To: City of Scottsdale

Summary of Modifications

Civil and Landscape Drawings

Architectural Elevations and Building Design

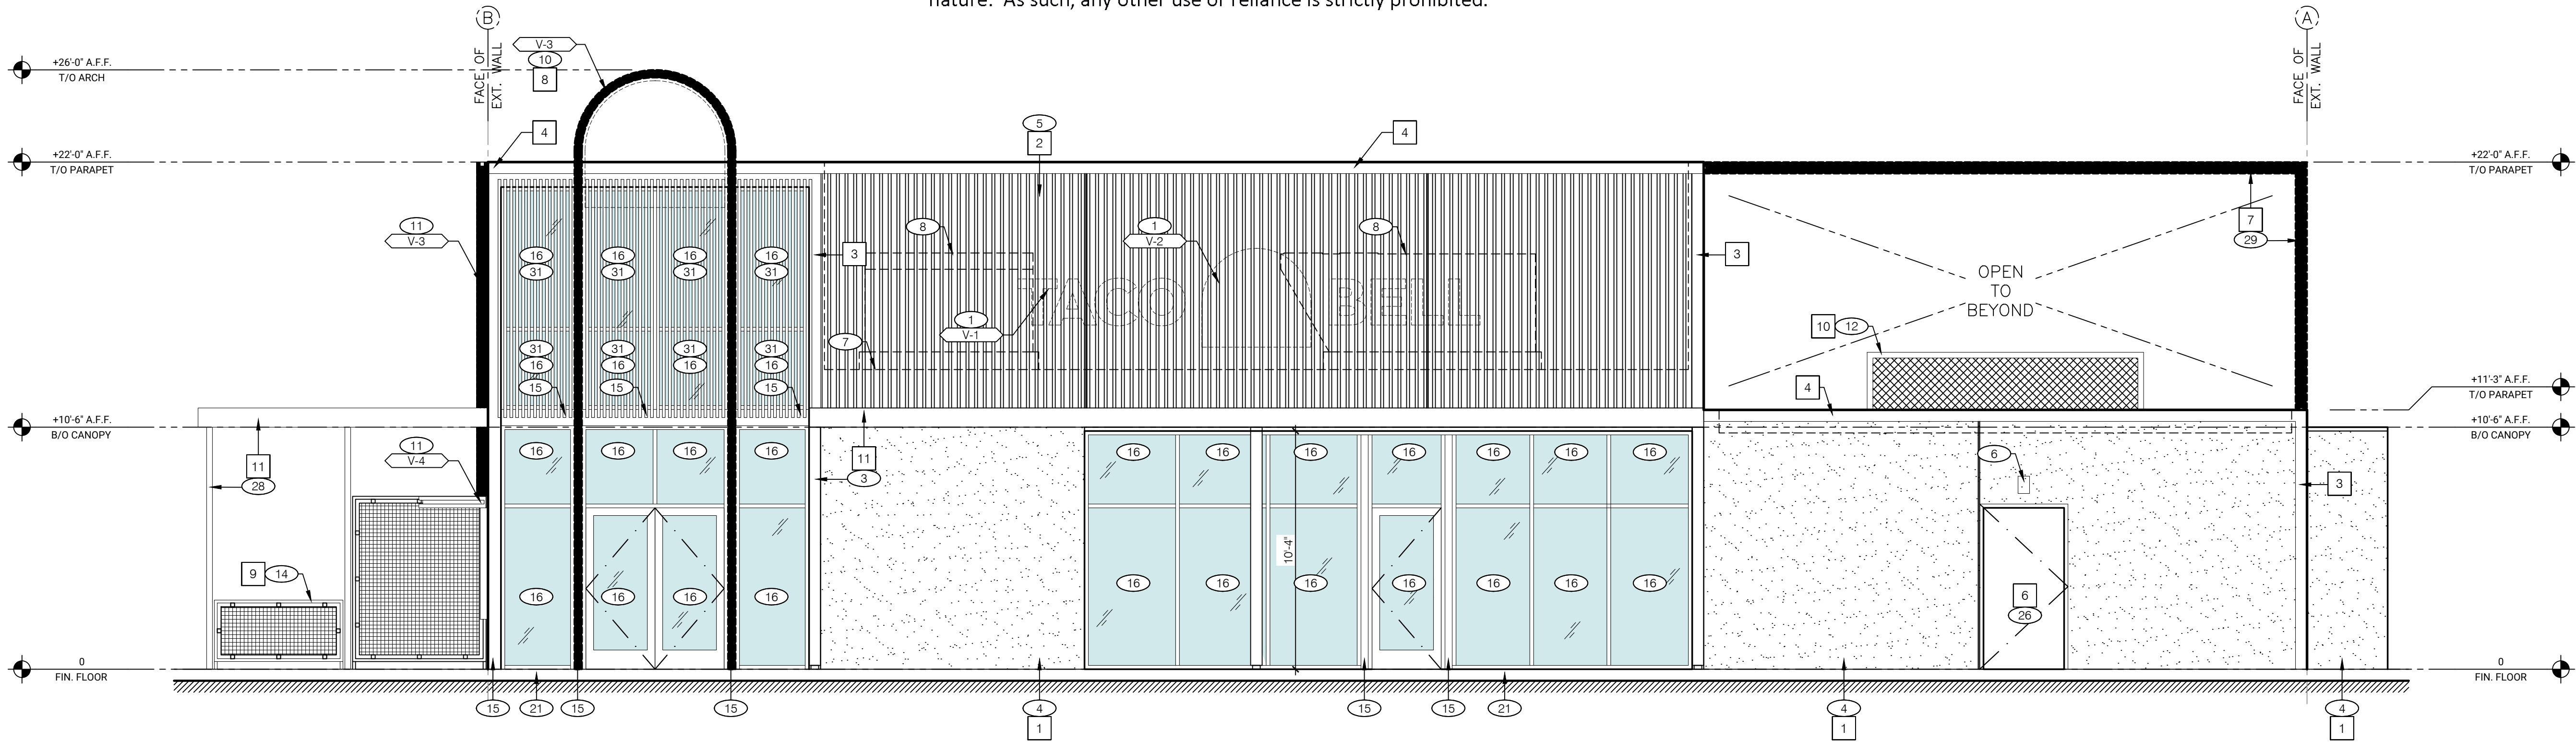
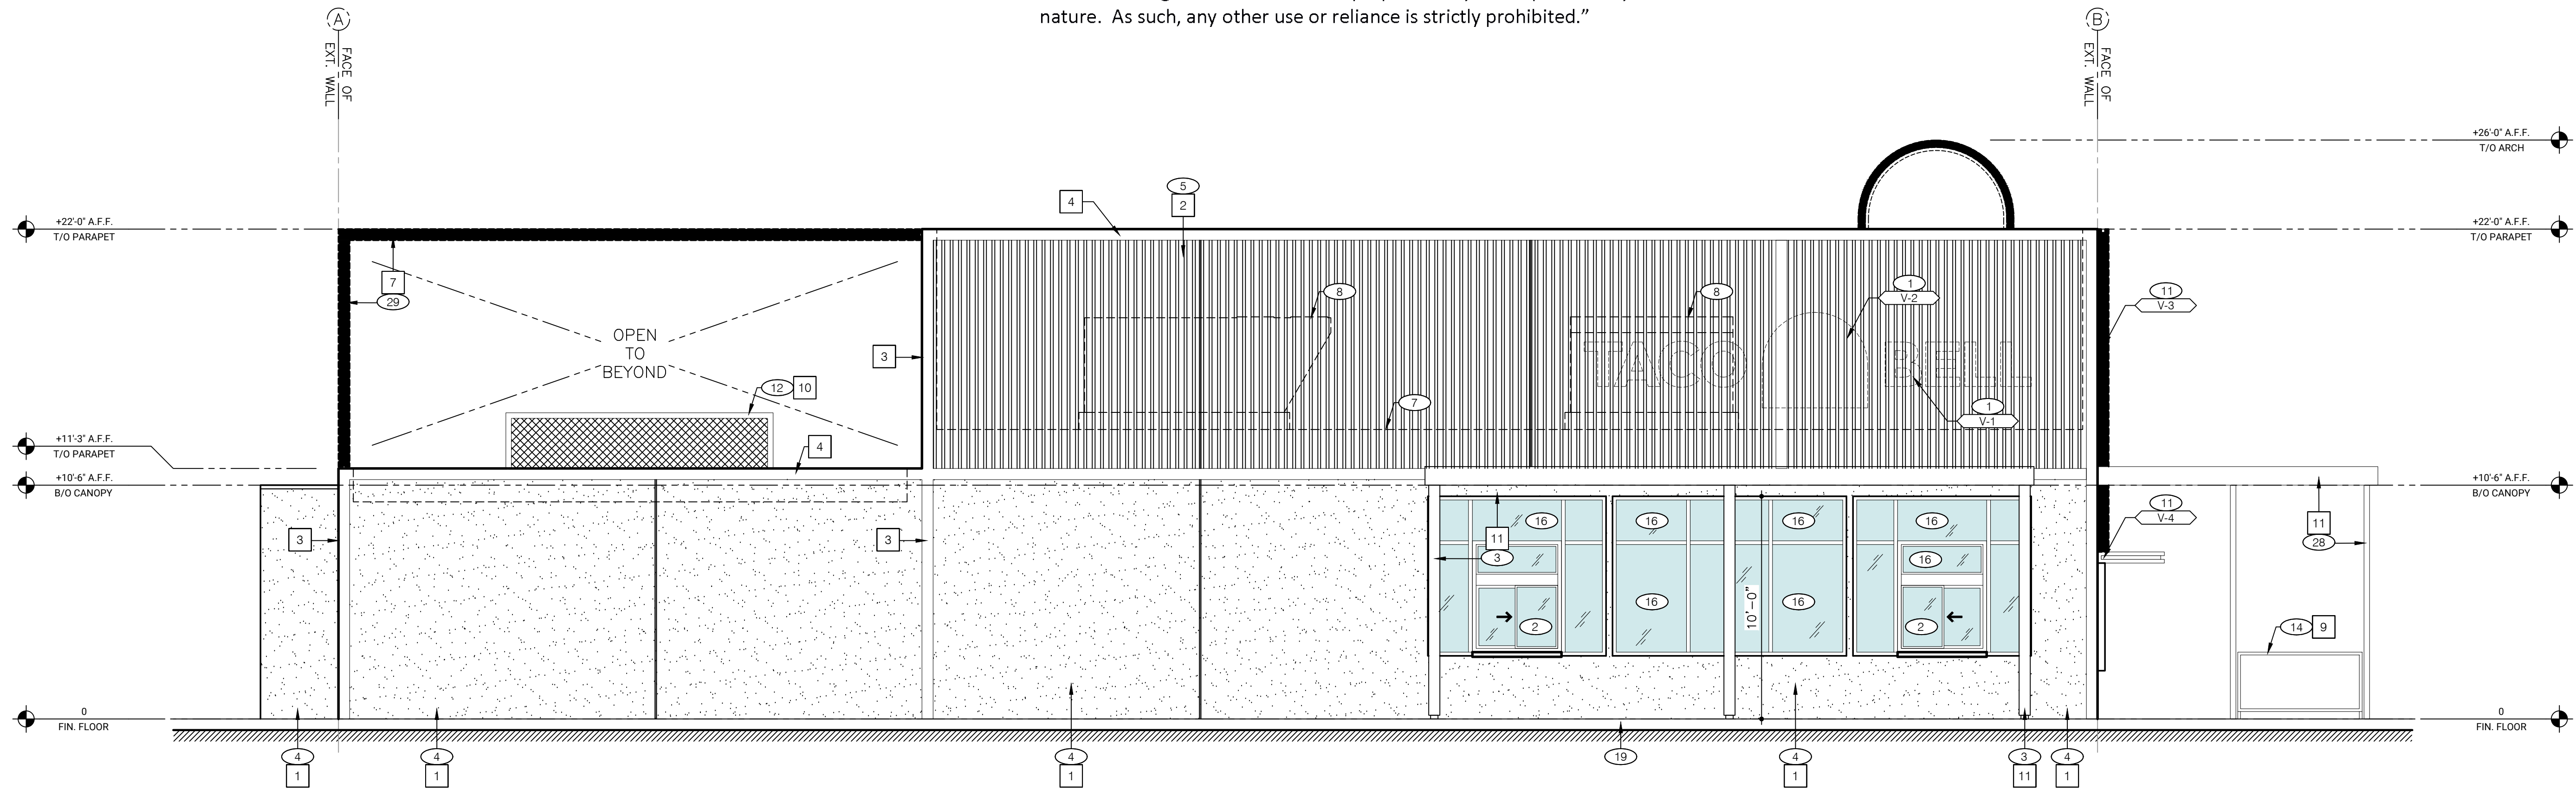
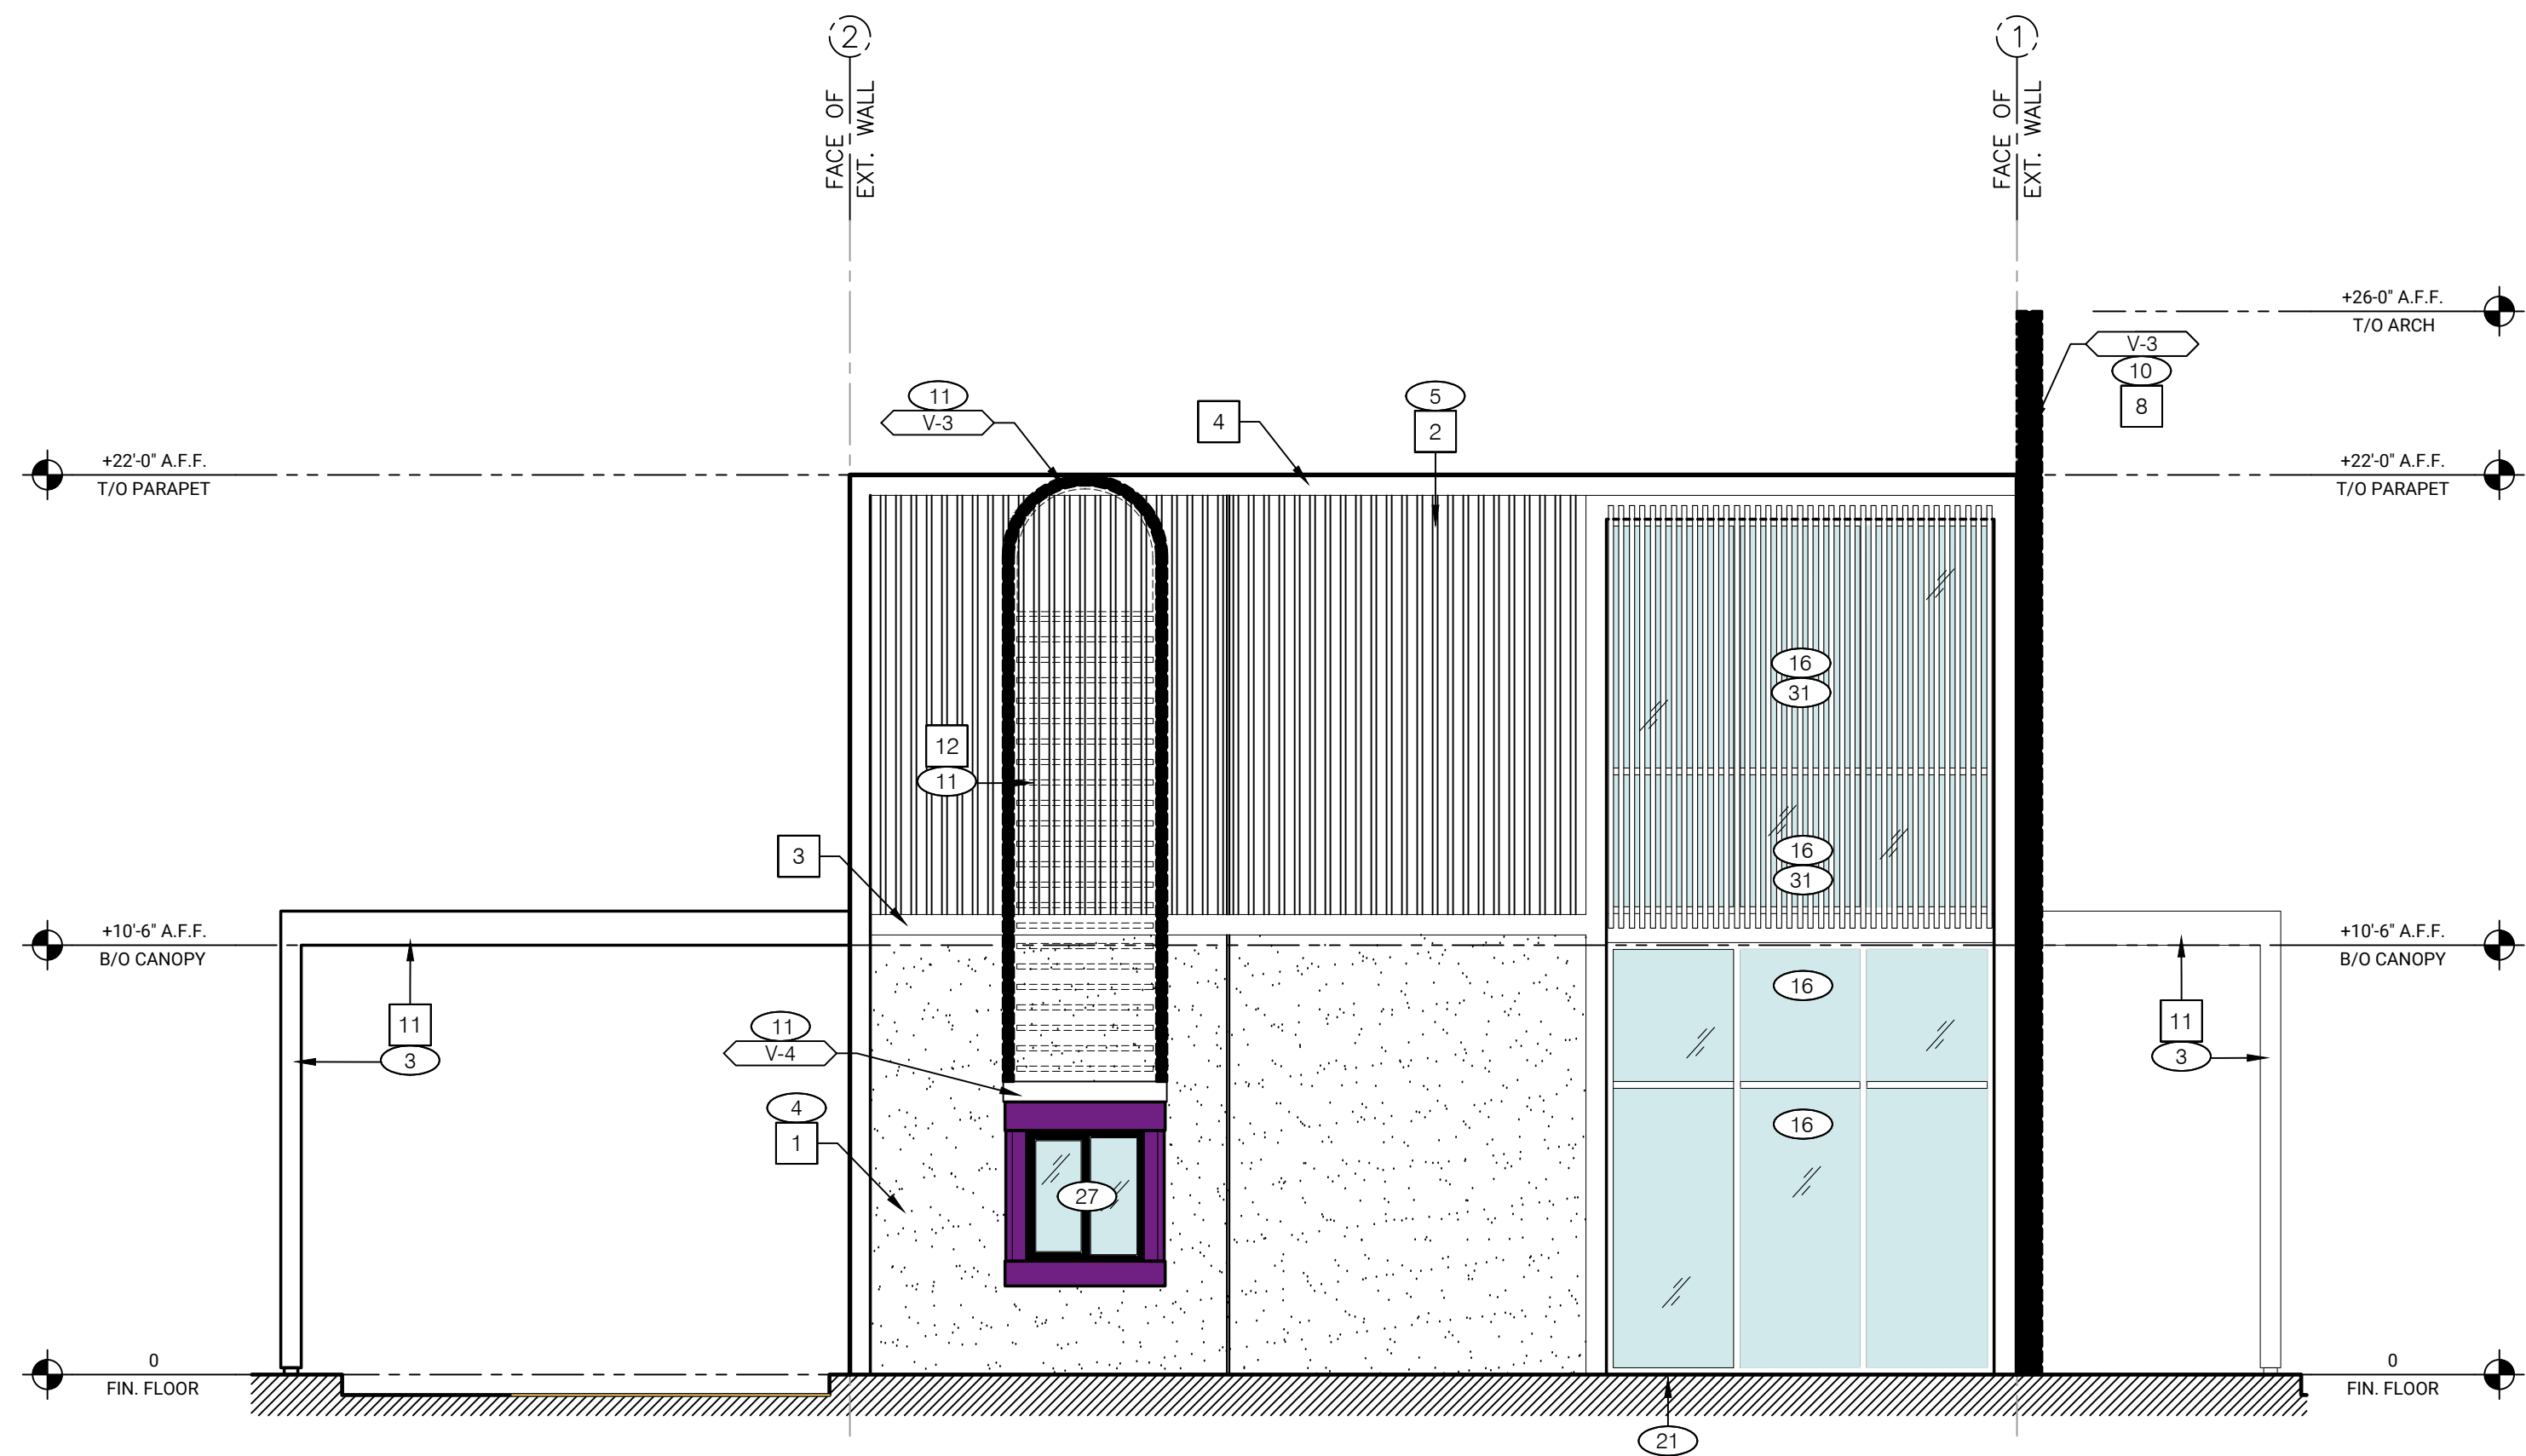
- Revised elevation labels per comments.
- Included rendering of all elevations.
- Clarified detailing of the patio and railing.
- Enclosed all meters on rear of building.
- Provided detailing on door/windows wall recesses.
- Revised all finishes on building.
- Included a mural on building.
- Provided vertical louvers at primary tower element.
- Removed signage from portal “tombstone” at primary entrance.
- Extended front canopy to connect to building at banding.
- Added roof and floor plans.
- Clarified canopies on all three primary sides of building, connected to building mass, as integral elements.
